State of New Mexico
Energy, Minerals and Natural Resources

Form C-103
Revised July 18, 2013

WELL API NO.	30-025-30153
5. Indicate Type of Lease STATE ☐ FEE ☒	
6. State Oil & Gas Lease No.	313857
7. Lease Name or Unit Agreement Name	WEST DOLLARHIDE QUEEN SANDS UNIT
8. Well Number	101
9. OGRID Number	309777
10. Pool name or Wildcat	18810
4. Well Location Unit Letter <u>N</u> : <u>1610</u> feet from the <u>W</u> line and <u>1090</u> feet from the <u>S</u> line Section <u>30</u> Township <u>24S</u> Range <u>38E</u> NMPM County <u>LEA</u>	
11. Elevation (Show whether DR, RKB, RT, GR, etc.) 3130 KB

WELLBORE DIAGRAM
WEST DOLLARHIDE QUEEN SAND UNIT #101

WELLBORE DIAGRAM
WEST DOLLARHIDE QUEEN SAND UNIT #101
PROPOSED
API: 30-025-30153

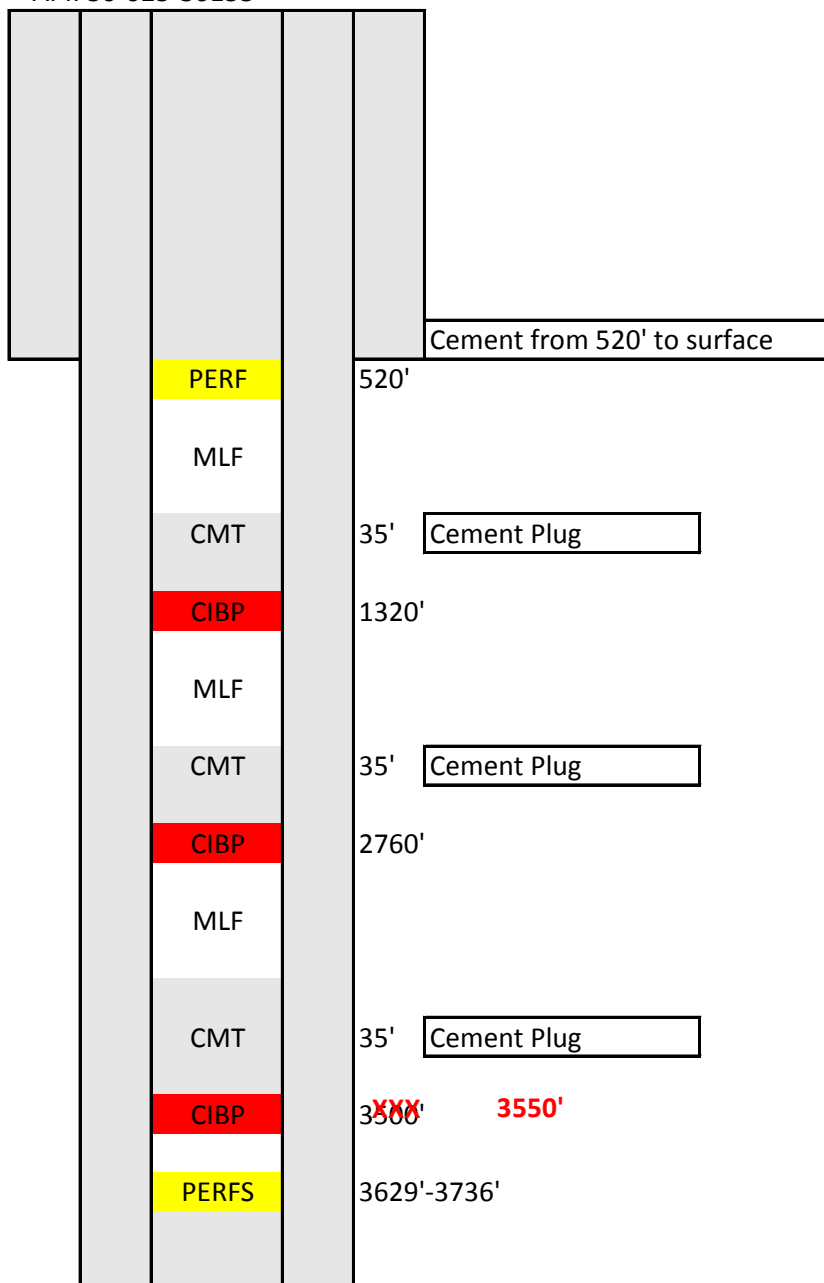
3550' MIRU P&A UNIT. POOH W/ EXISTING STRING. RU EWL & SET CIBP @ ~~3500'~~
 3500' OVER EXISTING PERFS @ 3629 - 3736. PU WORKSTRING & SPOT
 35 FT CMT PLUG. SET 2ND CIBP @ 2760 & SPOT 35 FT CMT PLUG ON
 CIBP. SET 3RD CIBP @ 1320 W/ 35 FT CMT PLUG ON CIBP. PERF AT 520
 & CIRC CMT TO SFC. OPERATIONS TO P&A WELL WILL BEGIN
 IMMEDIATELY FOLLOWING APPROVAL.

4" diameter 4' tall Above Ground Marker

Created By	Condition	Condition Date
kfortner	See attached conditions of approval Note changes to procedure	9/7/2021
